# Comhairle Chontae Atha Cliath Theas

**PR/0374/22**

## Record of Executive Business and Chief Executive's Order

**Reg. Reference:** SD21A/0181

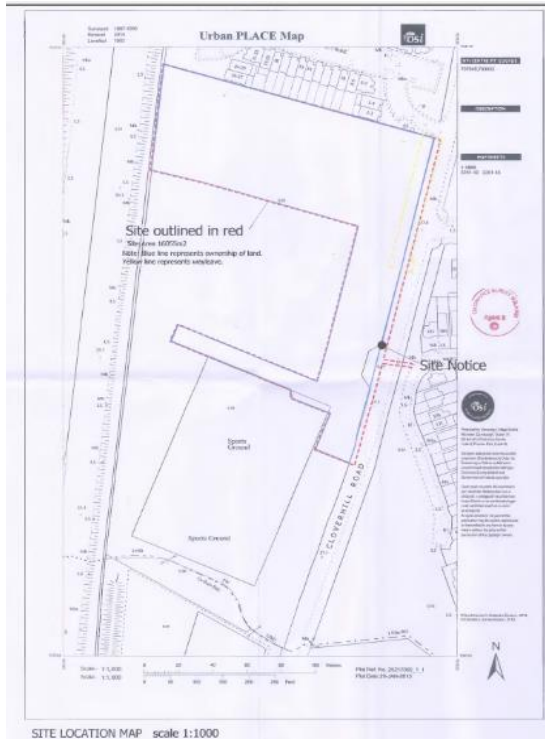
#### ***Red Line***

The redline for SD15A/0105 was:

The proposed application alters the proposed red line quite significantly:

It is apparent that the red line for the current application excludes areas which it is seeking to change. It also includes additional areas within the redline which were not previously included. The applicant is therefore requested to submit a revised site location plan. For clarity, this should cover the extent of the redline under SD15A/0105, as well as any additional areas. As there are amendments to the redline this would be **significant additional information**. Revised newspaper and site notices should therefore be provided. In addition to this, it is noted that the notices do not currently set out that the current application is proposing to change the red line from that which was previously granted. The revised notices should address this matter.
